TITLE: Application of Dr. Claudette Spencer to rezone property from R-75 (Residential Medium Lot-75) zoning district to MU-1 (Mixed-Use Low Density) zoning district to allow for an adult day care facility, at 911 Mountain View Drive.

PETITION NO: N1-2024-0626 Z-24-1246990

### **STAFF ANALYSIS**

### **ZONING COMMENTS – JUNE 2024**

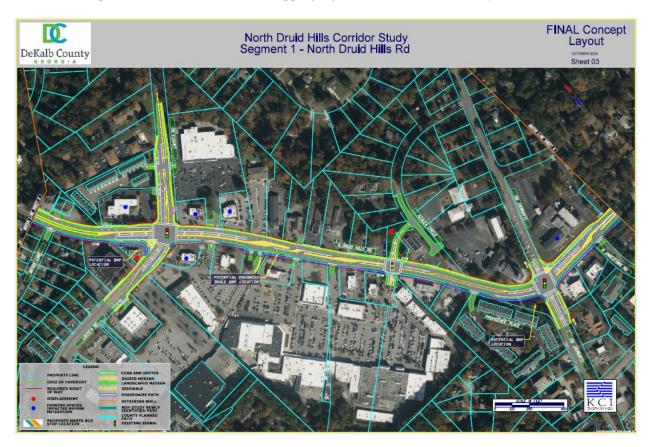
N1. 911 Mountain View Drive. Mountain View Drive is classified as a collector road. If a land development permit is required- Please refer to the requirements in Zoning Code 5.4.3 and Land Development Code 14-190. Requires a right of way dedication of 35 feet from centerline OR such that all public infrastructure is within right of way, whichever greater. Requires a 10-foot landscape strip with a 6-foot sidewalk and 4-foot bike lane OR (PREFERRED) a 10-foot multiuse path. Requires pedestrian scale streetlights. (<a href="hefowler@dekalbcountyga.gov">hefowler@dekalbcountyga.gov</a>). Mountain View Circle and Mountain Springs Way are classified as local roads. Please refer to the requirements in Zoning Code 5.4.3 and Land Development Code 14-190. Requires a right of way dedication of 27.5 feet from centerline OR such that all public infrastructure is within right of way, whichever greater. Requires a 5-foot landscape strip with a 5-foot sidewalk. Requires pedestrian scale streetlights. (<a href="hefowler@dekalbcountyga.gov">hefowler@dekalbcountyga.gov</a>). No poles may remain within the limits of the path/sidewalk on any street. Only one access point allowed on Mountain View Drive. Refer to Code Section 14-200 (6) for driveway spacing. Consider the circulation loop having access off Mountain View Circle. No parking allowed on the right of way. Verify that all access points have intersection and stopping sight distance as described by AASHTO.
